# Access Compliance Report

## Public Rights-of-Way

### (Curb Ramps)

Intersection ID: 15174	Main Street: DILWORTH_RD_WEST	Cross Street: IDEAL_WY	Location: NW
ADA ID: D8DE64C3E4FD	Ramp Type: Directional1	Initial Pass/Fail: Fail	Overall Compliance: No
Severity Score: 1.25			
Codes/Mitigation Info/Possible Solution		Field Measurements/Component Compliance

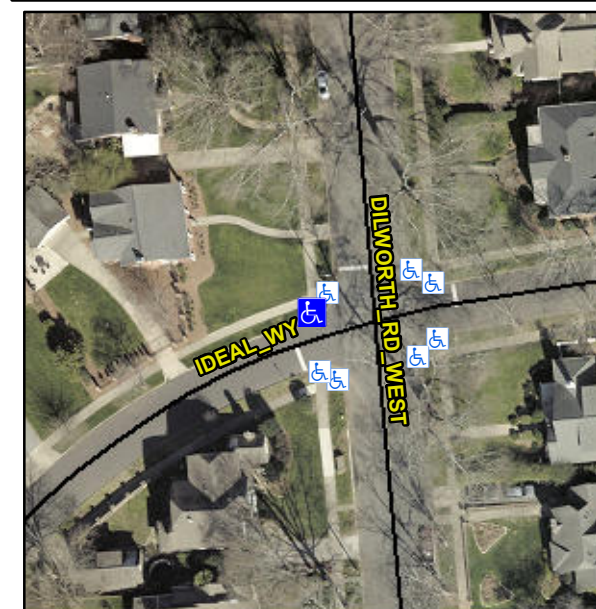
**R304.5.3**

Compliance	Description	Data	Compliance	Description	Data
N/A	Ramp Length (in)	71.0	N/A	Grade Break?	N/A
Yes	Ramp Width (in)	55.0	N/A	Grade Break Slope (%)	0.0
Yes	Ramp Slope (%)	5.2	N/A	Grade Break XSlope (%)	0.0
No	Ramp XSlope (%)	2.1			
N/A	Flare Type LT	N/A	N/A	Flare Type RT	N/A
N/A	Flare Slope LT (%)	N/A	N/A	Flare Slope RT (%)	0.0
N/A	Flare Traversable LT?	N/A	N/A	Flare Traversable RT?	N/A
N/A	Landing Length (in)	0.0	N/A	DWS Provided?	N/A
N/A	Landing Width (in)	0.0	N/A	DWS Contrast?	N/A
N/A	Landing Slope (%)	0.0	N/A	DWS Length (in)	N/A
N/A	Landing X Slope (%)	0.0	N/A	DWS Full Width?	N/A
N/A	Landing Curb? (Y/N)	N/A	N/A	DWS Offset LT (in)	N/A
N/A	Shared Landing?	N/A	N/A	DWS Offset RT (in)	N/A
N/A	Gutter Ponding?	0.0	N/A	Gutter Slope (%)	N/A
N/A	Gutter Lip Ht (in)	1.0	N/A	Gutter X Slope (%)	N/A
N/A	Painted X Walk1?	No		Road Slope (%)	5.3
	X Walk 1 Direction	To SE		Road X Slope (%)	3.2
	X Walk 1 Width (in)	N/A		Clear Space?	N/A

X Walk 1 Slope (%)	5.3	N/A	Clear Space to XWalk (in)	N/A
	X Walk 1 X Slope (%)	3.2	N/A	Storm Grate/Utility Hazard?	N/A
N/A	Ramp inside XWalk1?	N/A		Storm Grate/Utility Type	
N/A	Any Obstructions?	N/A			N/A
	Obstruction Type		Yes	Surface Condition? (G/P)	Good
			N/A	Curb Slope (%)	13.2

**Remove & Replace Entire Ramp.**
